ARCHITECT'S SUPPLEMENTAL INSTRUCTION

PROJECT:	La Vista City Center - MU Bldg - South/15	PROJECT NO.:	F16132
CONTRACTOR:	Overland Construction	DATE:	08/08/2017
REFERENCE:	Structural Revision	ASI NO.:	#1

PROJECT: LA VISTA CITY CENTRE
MIXED USE - LOT 15

13 DETAIL

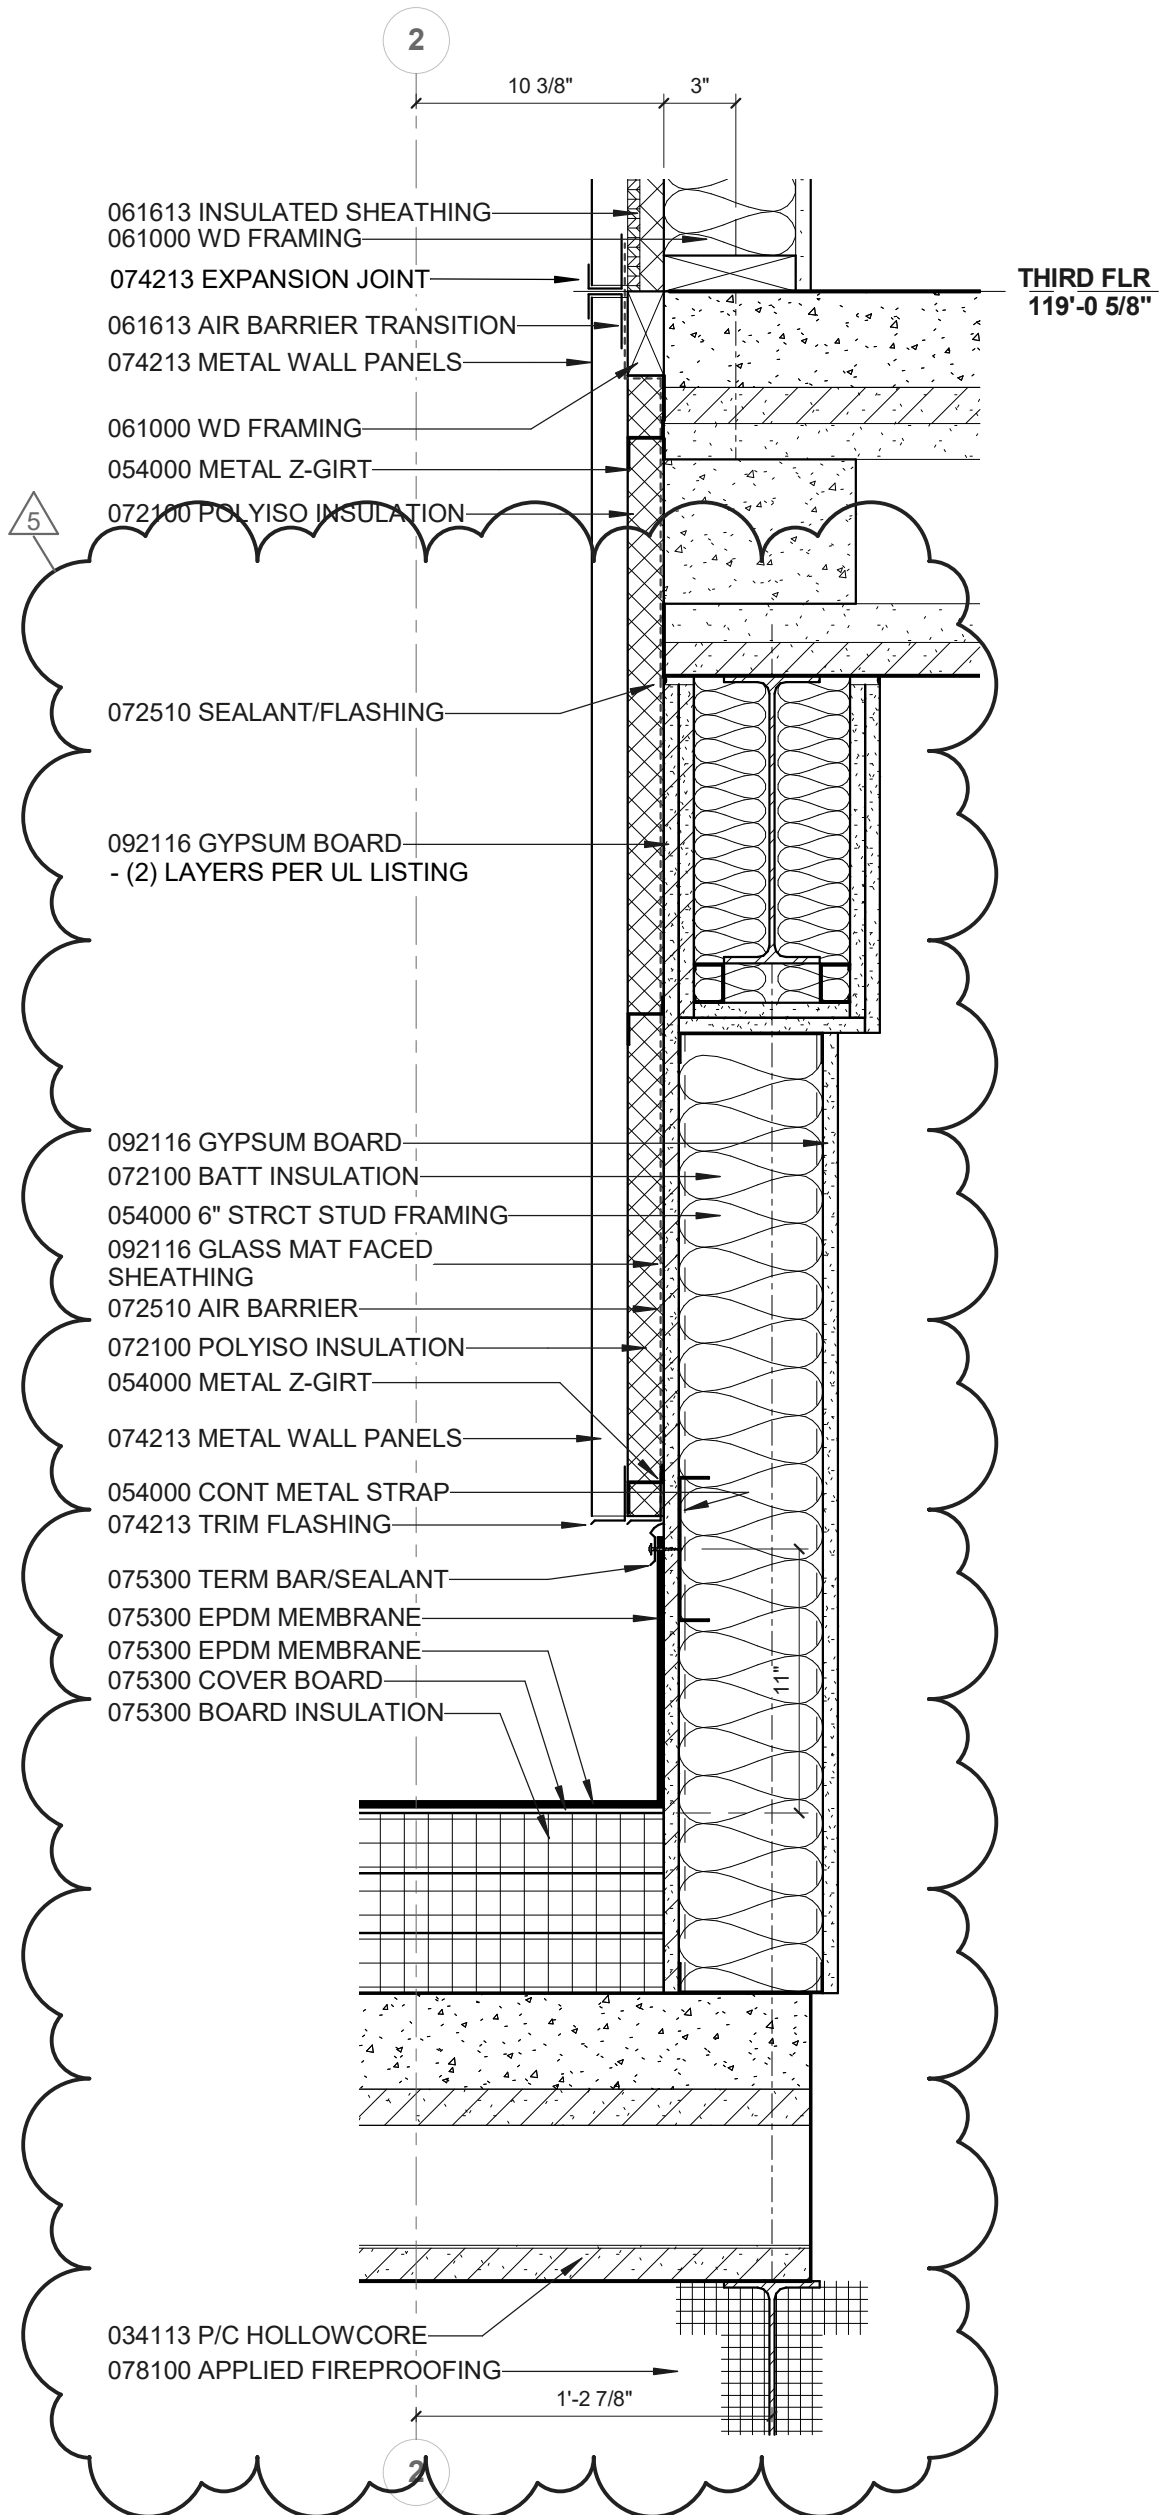
1. In reference to RFI #1; Revise HSS6x6x5/8 Column and associated Beam line East of Gridline C-2 per attached Detail 13/A5.2 and drawings S201 and S203.
